TITLE: **PRELIMINARY PLAT NO. 01005, MUFF 2ND ADDITION**, requested by J.D. Burt of Design Associates on behalf of Park Ridge Apartments, L.L.C., for 12 lots, on property generally located at S.W. 8th and West "C" Streets.

Re: Preliminary Plat No. 01005
Muff 2nd Addition

P.A.S.#: **Muff 2nd Addition**
Change of Zone #3323
Special Permit #1733B
Preliminary Plat #01005

RE: Preliminary Plat #01005
Special Permit #1733B
Change of Zone #3323

**Preliminary Plat #01005
SW 8th & West 'C'**

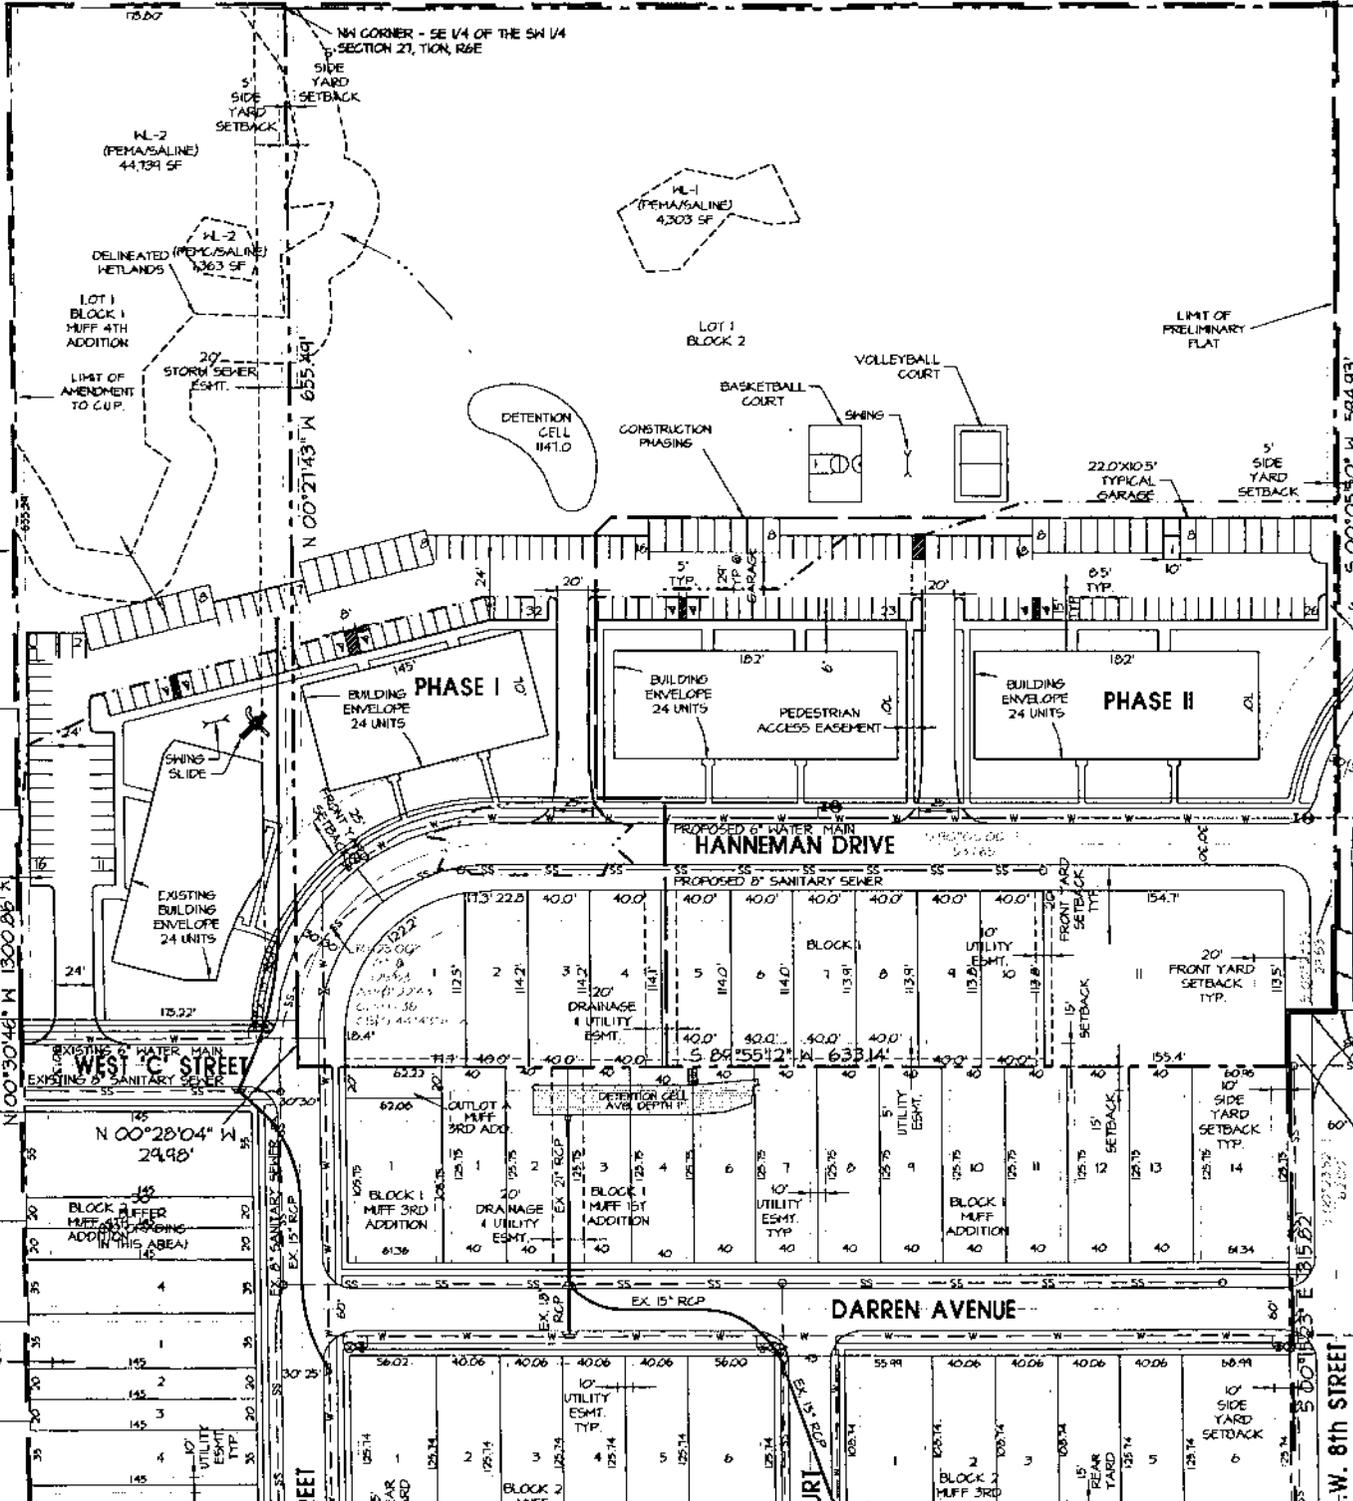
- 1.1 Revise the preliminary plat to show:
 - 1.1.1 Street trees labeled as requested by Parks & Recreation
 - 1.1.2 Move the fire hydrant at the east end of Hanneman Drive out of the center of the right-of way.

- 1.1.3 Correct the parking stall dimensions: the "typical" dimension disagrees with the label in the parking area.
 - 1.1.4 Show the sidewalk on the south side of Hanneman Drive.

- 1.1.5 Replace "special use permit" with "preliminary plat" in the Planning Commission approval block.
 - 1.1.6 Show the east-west tree line located approximately 200' north of Trimble and indicate which trees are to be removed.

- 1.1.7 The setback labels in the already platted areas should be labeled as utility easements.
2. The City Council approves associated requests:
